**Re: Petition No. 1593** – The Connecticut Light and Power Company d/b/a Eversource Energy petition for the proposed Montville Substation to North of Kitemaug Road Rebuild Project consisting of the replacement and reconductoring of electric transmission line structures along approximately 1.1 miles of its existing electric transmission line right-of-way shared by its existing 115-kilovolt (kV) 1090 and 1000 Lines between Montville Substation and approximately 1200 feet north of Kitemaug Road in Montville, Connecticut, and related electric transmission line and substation improvements. **Responses to Council Interrogatories**

**Responses to Council Interrogatories**

**PE 1593**

Norwich, CT  
Map Sheet 30 of 40  
Date: June, 2022

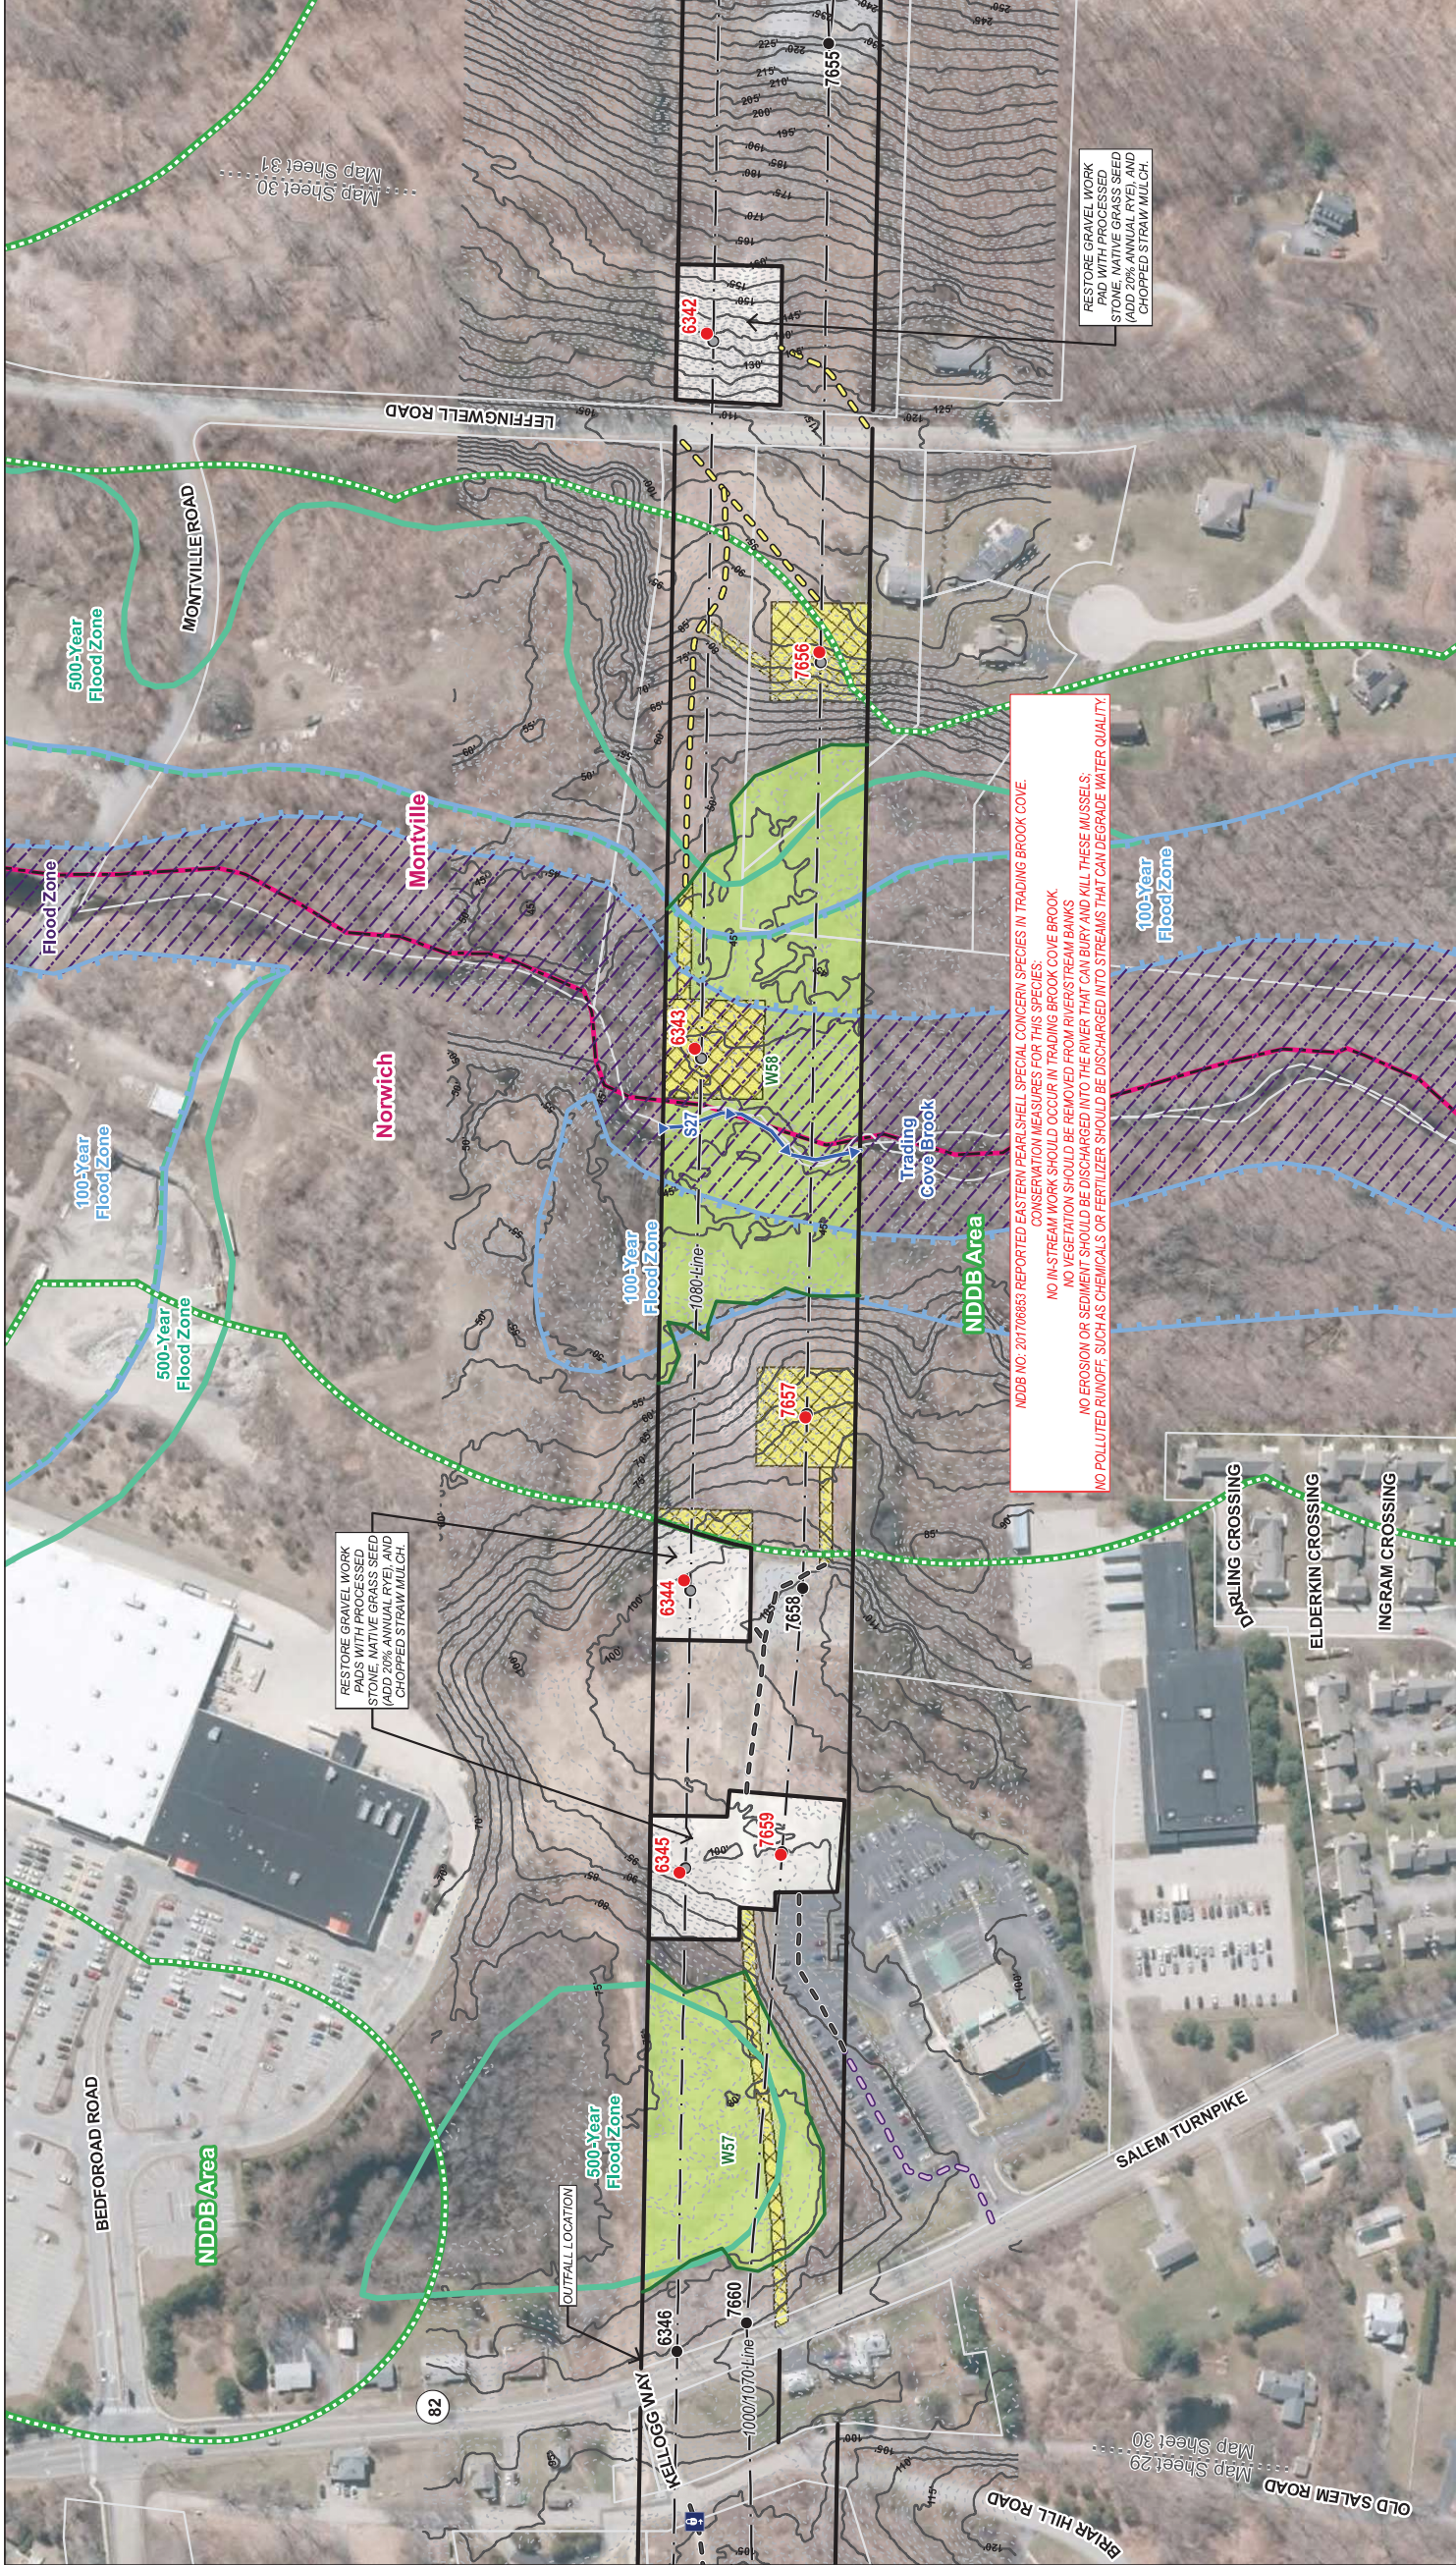
**Map Sheet 30**

**Spotted turtle (*Clemmys guttata*) State Status: Special Concern**

**Eastern pearlshell (*Margaritifera margaritifera*) State Status: Special Concern**

**Bridle shiner (*Notropis bifrenatus*) State Status: Special Concern**

**Spotted turtle (*Clemmys guttata*) State Status: Special Concern**

Land disturbance activities need to consider local habitat features and apply fencing and/or time of year restrictions as appropriate. We recommend you consult with a herpetologist familiar with preferred habitats to assist you with proper techniques to ensure the best protection strategies are employed for your site and the scope of your project.

**Eastern pearlshell (*Margaritifera margaritifera*) State Status: Special Concern**

**Bridle shiner (*Notropis bifrenatus*) State Status: Special Concern**

- Adhere strictly to water quality standards at your project site.
- No vegetation should be removed from the 100ft buffer of waterways.
- Turf grass and impervious surface should be minimized in the surrounding watershed.
- Ensure precautions are taken to avoid direct kill of freshwater mussels during any instream construction, modification or crossing.
- Employ precautions to prevent the introduction and spread of invasive plants and bivalves.
- Use best management practices available to control stormwater runoff from this site both during construction and after construction: Stock-piled soils should be situated at least 10 feet from the watercourse and within sedimentation and erosion control devices.
